Product / Process Change Notification (PCN)

PCN #: PCN_ConUSB2_20230425

Affected Series: WE-ConUSB;
629104151021

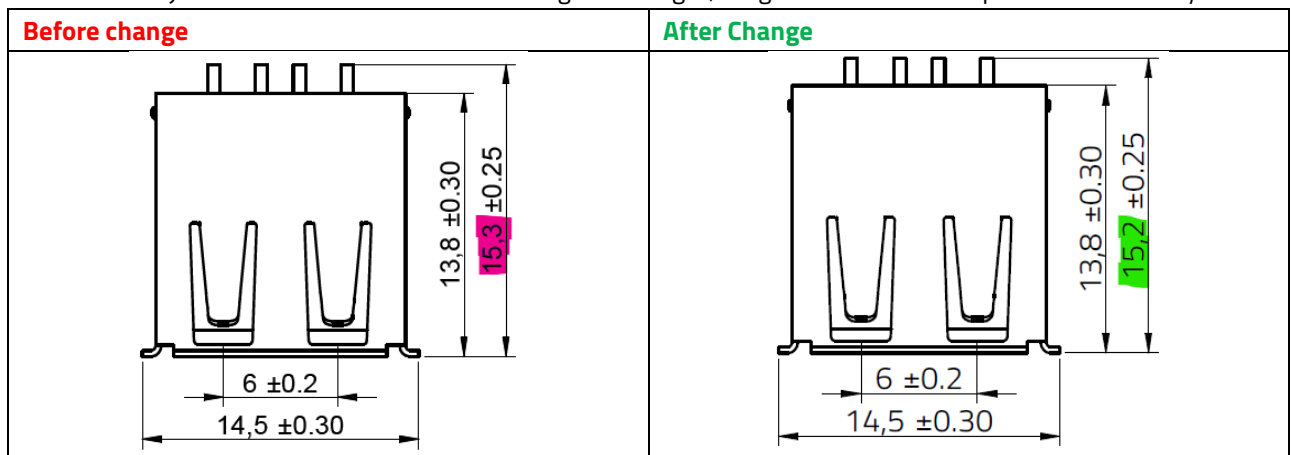
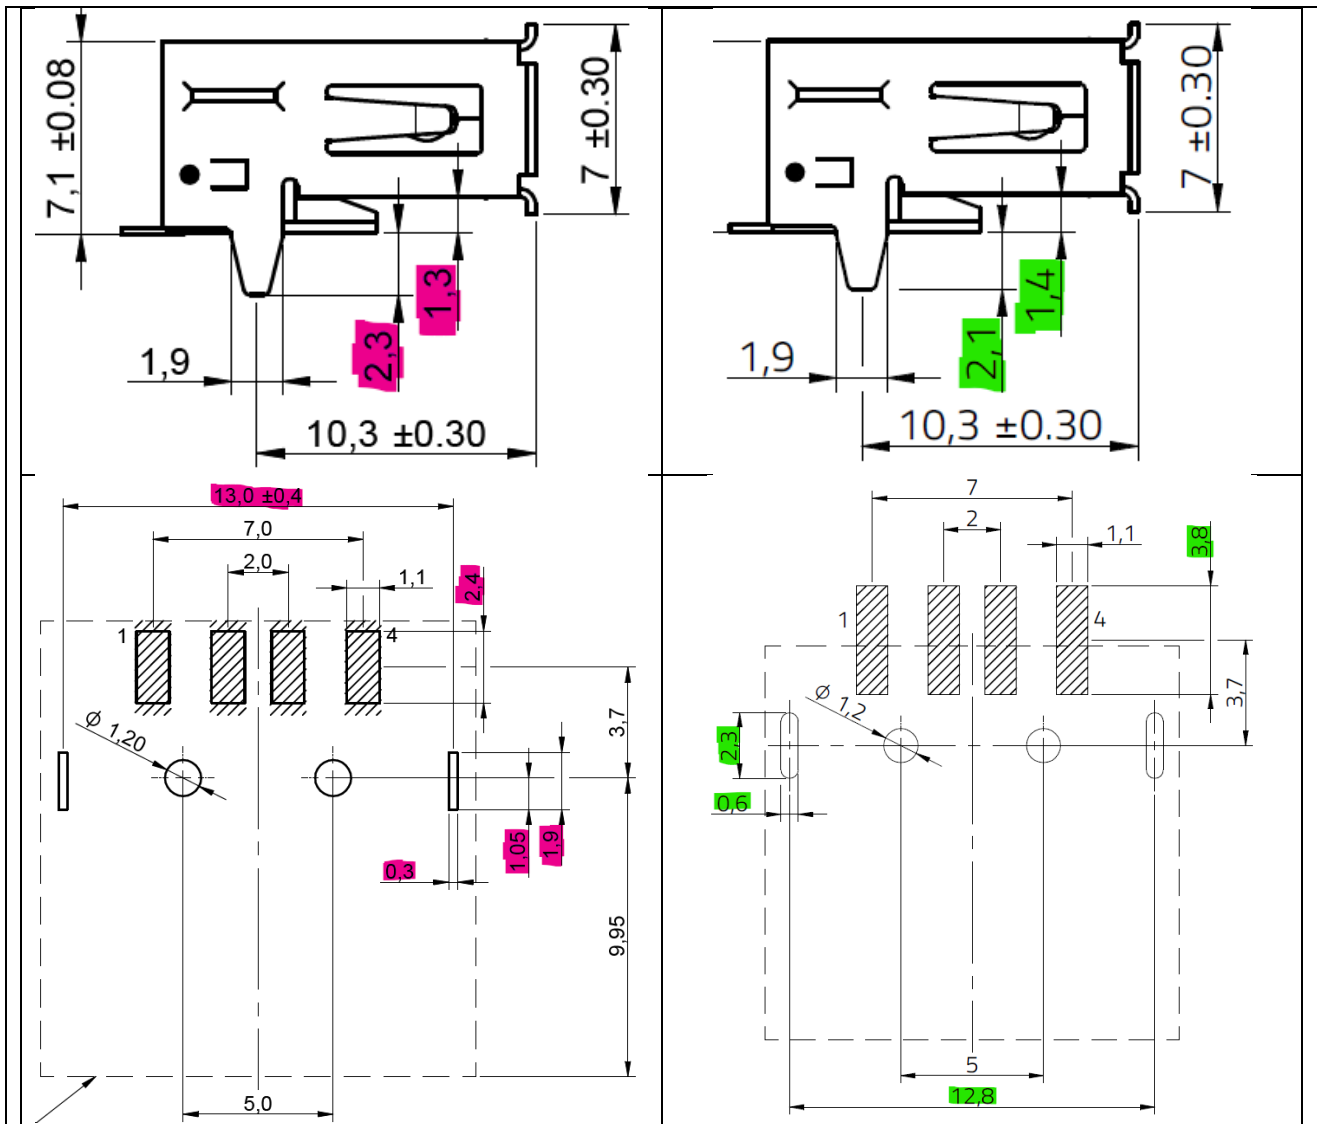
For the purpose of a datasheet information enlargement, Würth Elektronik will adjust the dimensions of the external shielding. This is a datasheet correction only. There will be no change in form, fit, function, quality or reliability of the product.

The overall dimensions of the shielding have be reviewed.

Most of the adjustments have been made on the global Length, Height of the retention pin and the PCB layout.
